SUBMITTAL SUMMARY REPORT MajorSite-000060-2025

PLAN NAME: Multi-Family- 8 Units - 351 Marion Oaks Blvd	LOCATION: 351 MARION OAKS BLVD OCALA,
APPLICATION DATE: 11/20/2025	PARCEL: 8004-0433-18
DESCRIPTION: New 8-unit residential building

DEVELOPMENT REVIEW COMMITTEE WAIVER REQUEST FORM

DRAWING NUMBER
LS-01

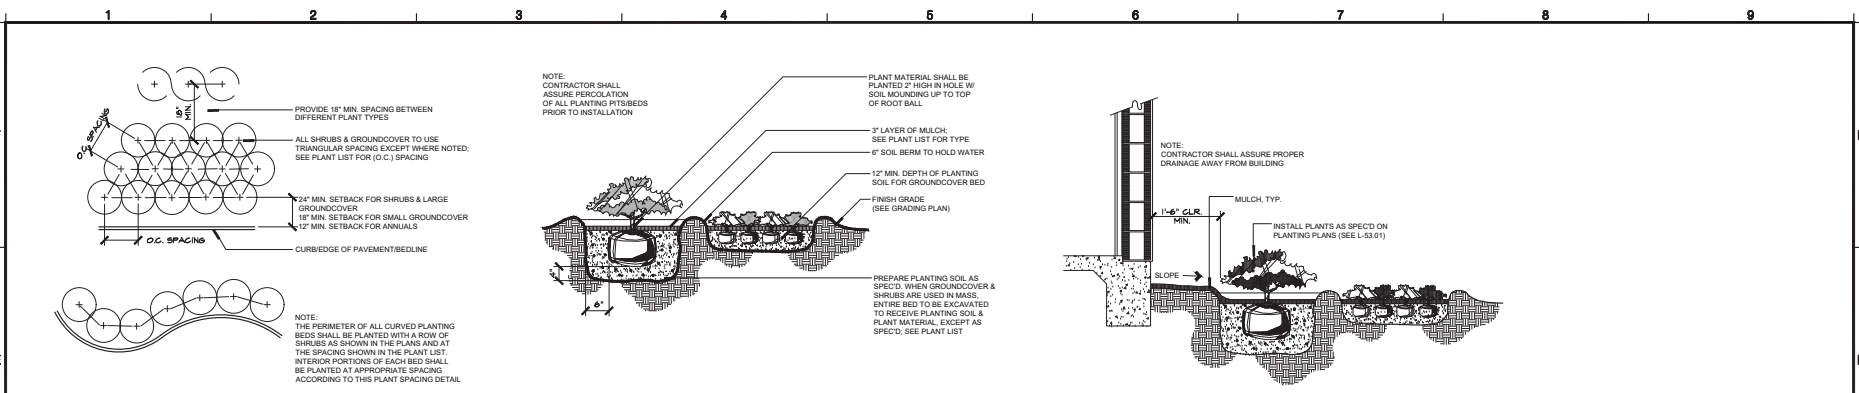
Section & Title of Code (be specific): Section 6.8.7 (D)- Parking Areas and Vehicular Use Areas
Reason/Justification for Request (be specific): Use evergreen understory trees in the parking islands, instead of shade trees
